Technical Memorandum

SUBJECT: Review of High Timber Resources, L.P. Simsboro Aquifer Evaluation Report

DATE: July 3, 2023

Revised Figure 7:
1-Year Analytical Drawdown

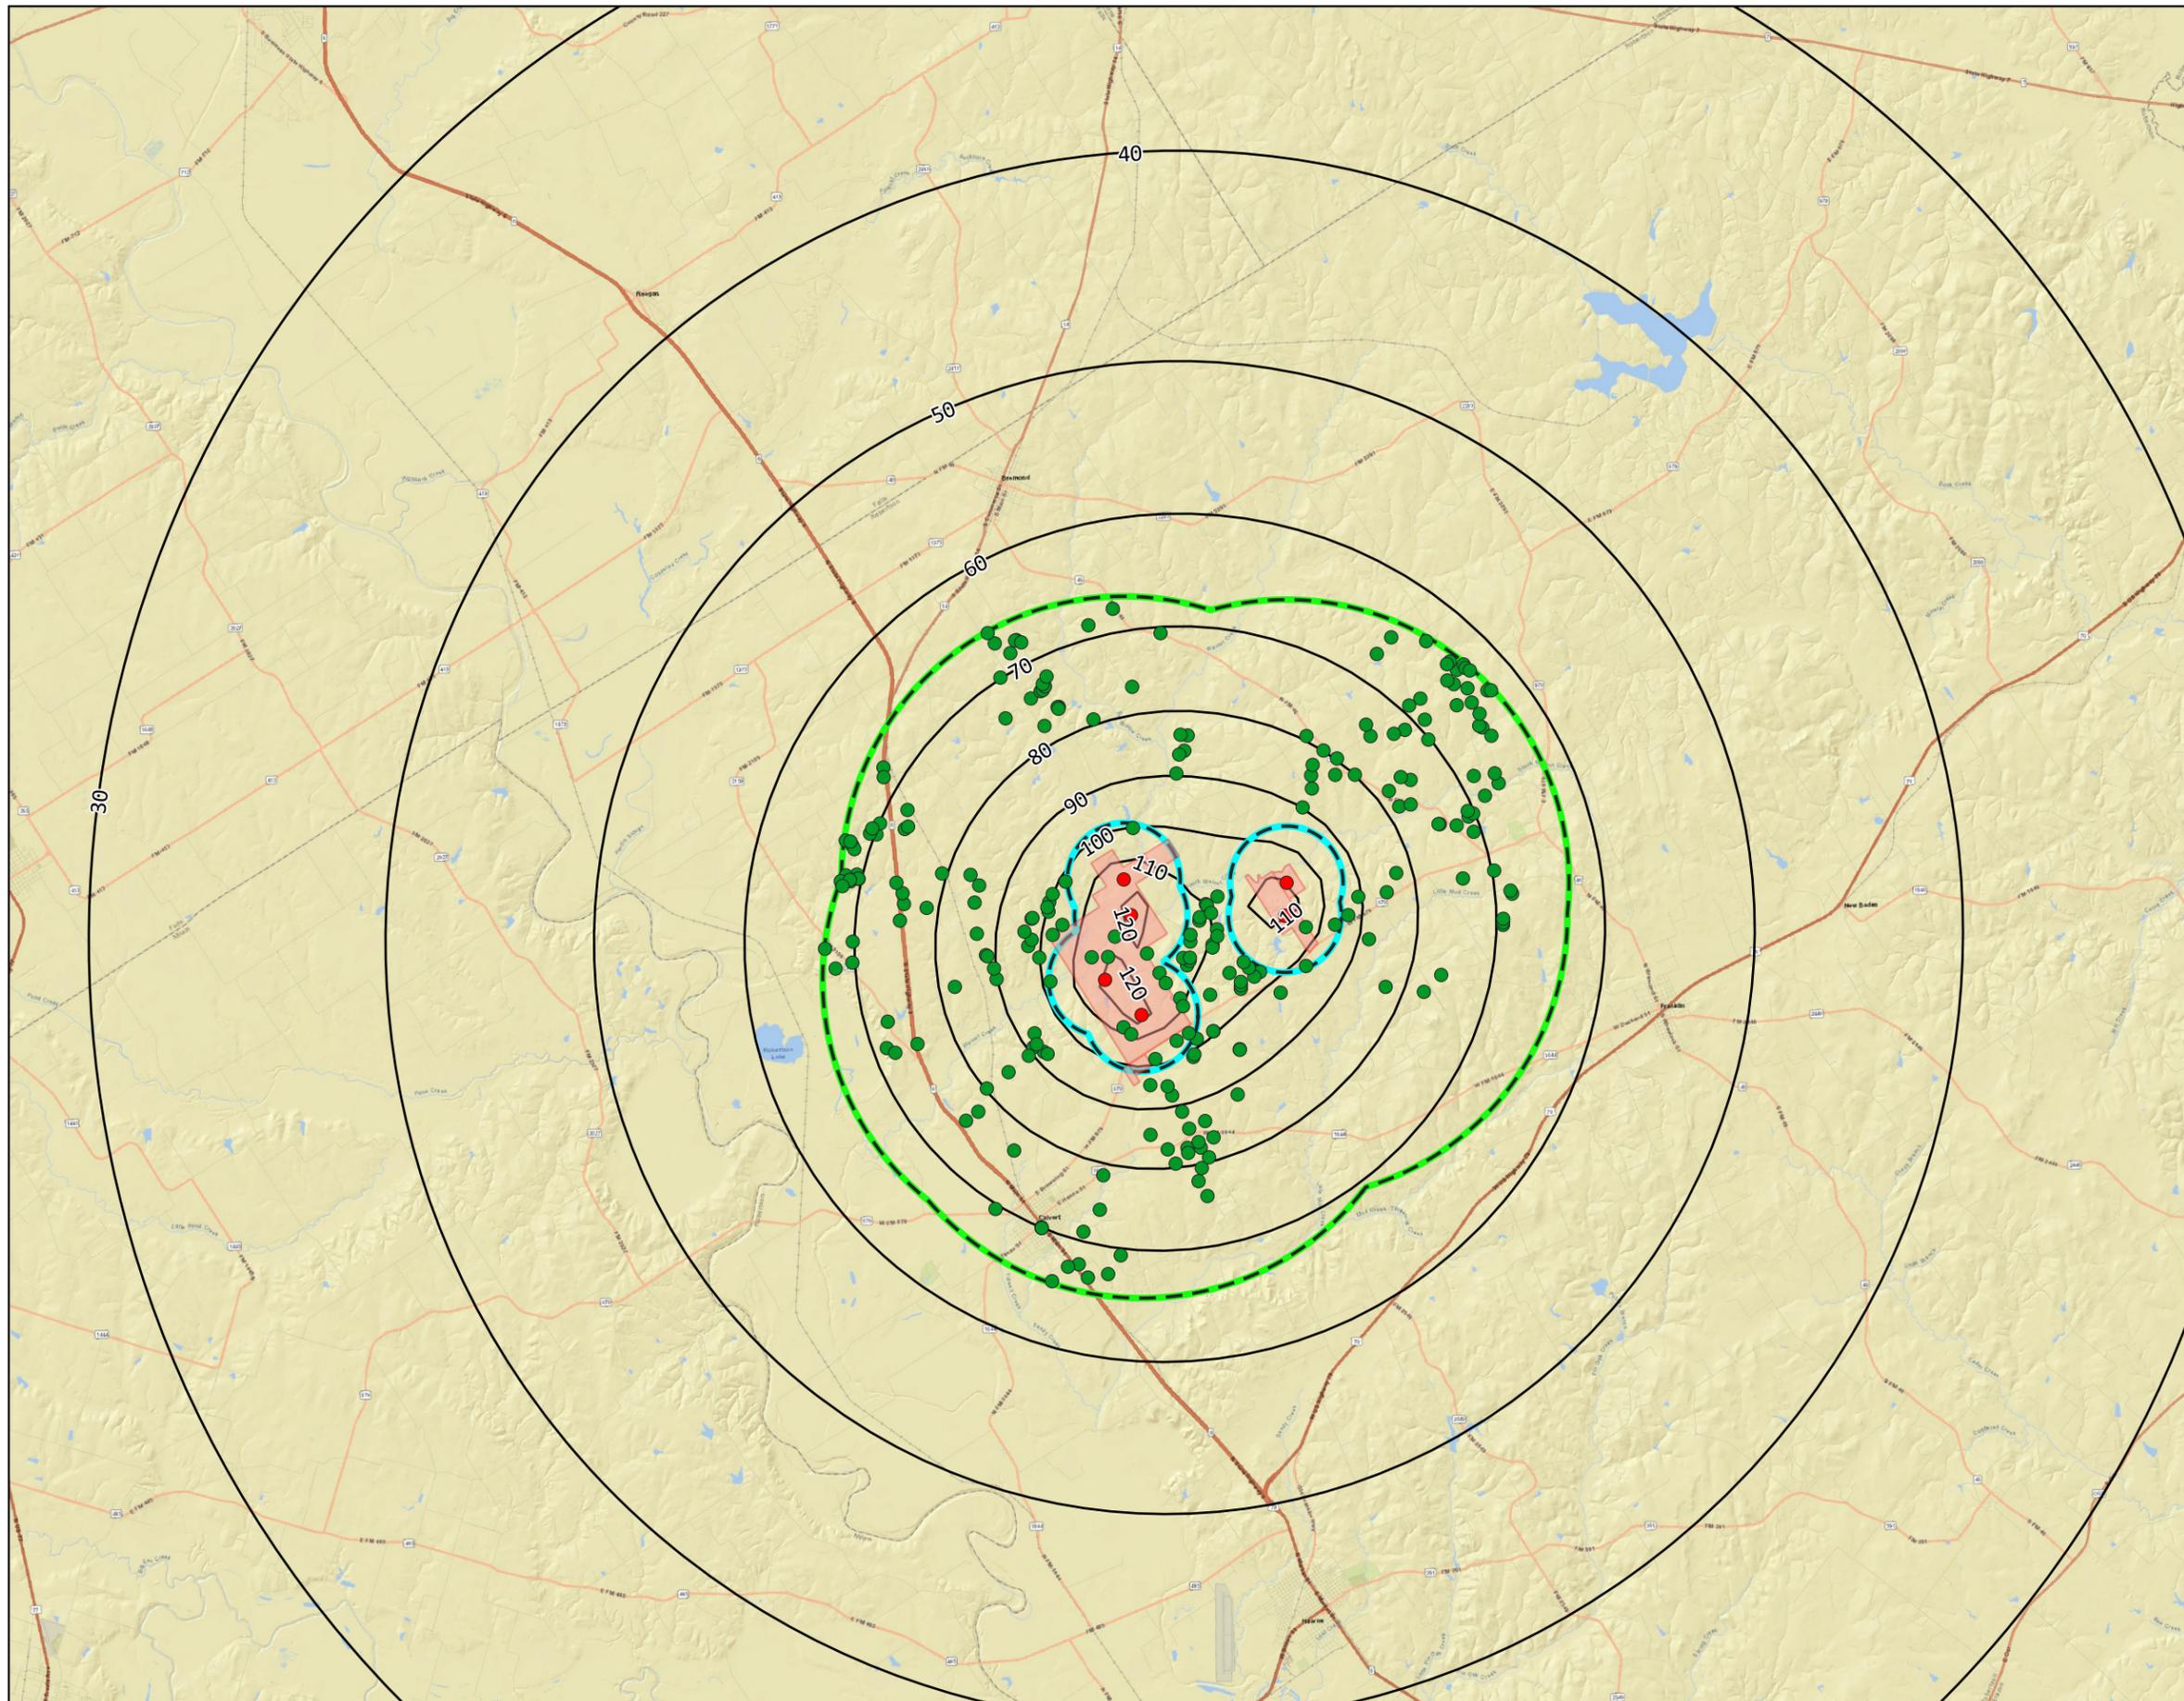
TGI used an analytical model based on the Theis non-equilibrium equation to estimate theoretical potentiometric head declines at and surrounding the proposed wells. TGI updated the analytical simulations as part of the June 13, 2023 supplemental response using a transmissivity value of 50,000 gallons per day per foot (gpd/ft) and storativity value of 0.0001 for the 1-year simulation and 0.001 for the 10-year simulation. TGI states that these parameters are based on a 45-day pumping test previously performed at the Walnut Creek mine. A copy of the updated TGI 1-year and 10-year analytical simulated interference drawdown illustrations from the June 13th supplemental letter (TGI Revised Figures 7 and 8) are attached to this memorandum. Table 1 provided in the AER was not updated by TGI in conjunction with the updated proposed High Timber Well analytical drawdown estimates developed by TGI as part of the June 13th supplemental response. TGI personnel indicated that they used the same method in the analytical approach that has been used in BVGCD in the past. That approach has historically included estimating analytical drawdown values at the proposed well locations by averaging the estimated drawdown at the well over the grid cell within the analytical tool.

The TGI analytical modeling results show less drawdown as a result of pumping the requested permitted amount of 11,870 ac-ft/yr at the proposed High Timber well locations than calculated by AGS. This may be due to the difference in application of the Theis analytical approach. To provide a drawdown at the well, AGS calculates the drawdown at the pumping wells at one foot from the well.
